THIRTEENTH REPORT
of the
TECHNICAL ASSISTANCE AND ADVISORY GROUP (TAAG)

Three Mile Island Unit 2 (TMI-2)
For the Period September 1, 1985 to January 31, 1986

Subject: Canister Transfer Shield Review

FIGURE 1

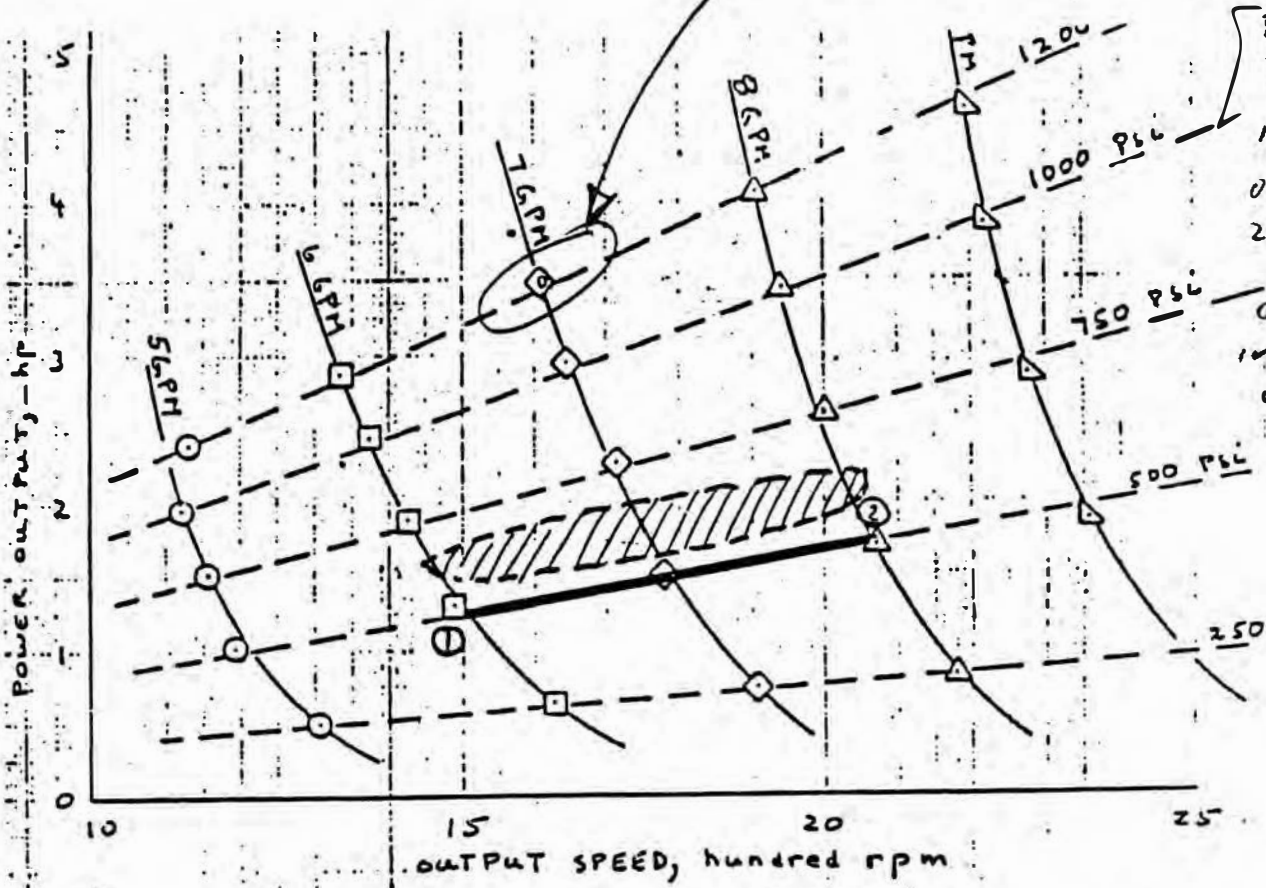
"Navy standard motor"
Tried 250 hours
in this region.
(about 10/84) Tried in
fresh water

Per Eastport
Int'l,
10/4/85
Only 1 or
2 motors
tried +
documented
in this
way.

FIGURE 2

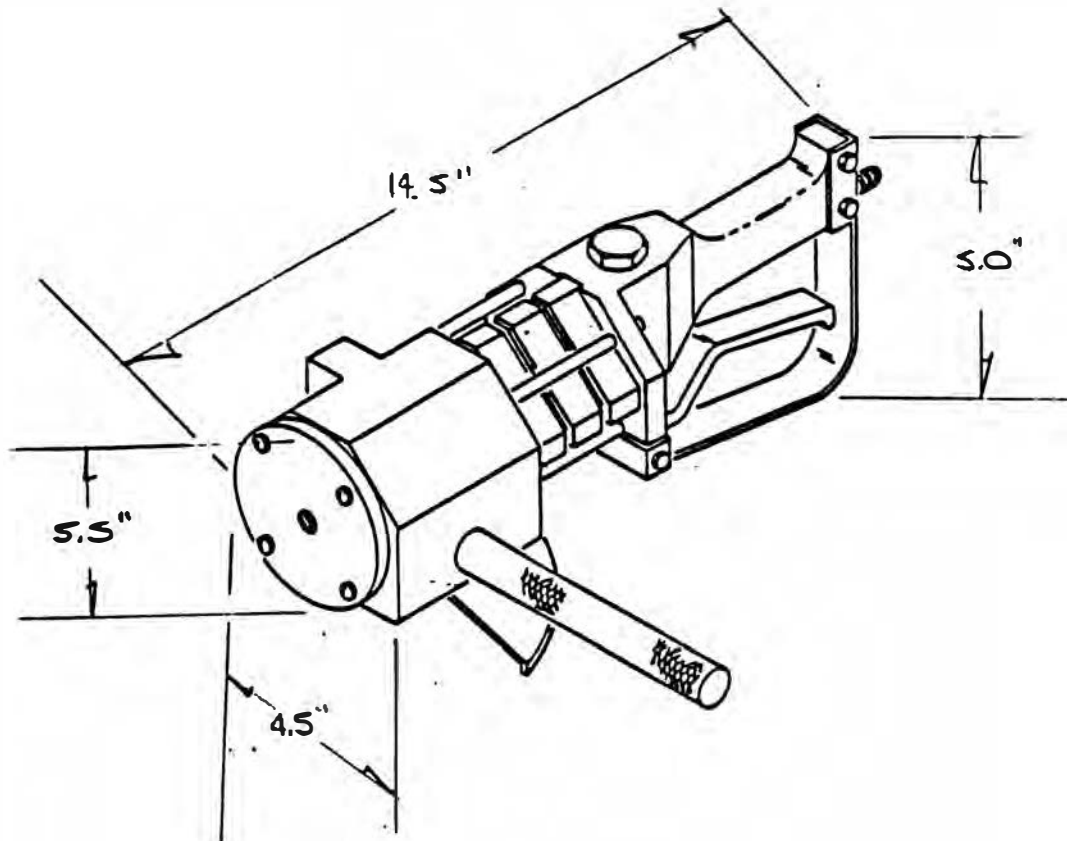
With the existing grinder/cut-off tool, the 7 inch diameter wheel protrudes about 1 5/8 inches from the end face of the tool (the end opposite the handle). That is, the maximum thickness that could be cut would be about 1 inch. Slightly greater wheel clearance may be achievable through changes in the tool head geometry. Larger diameter wheels would also provide more clearance.
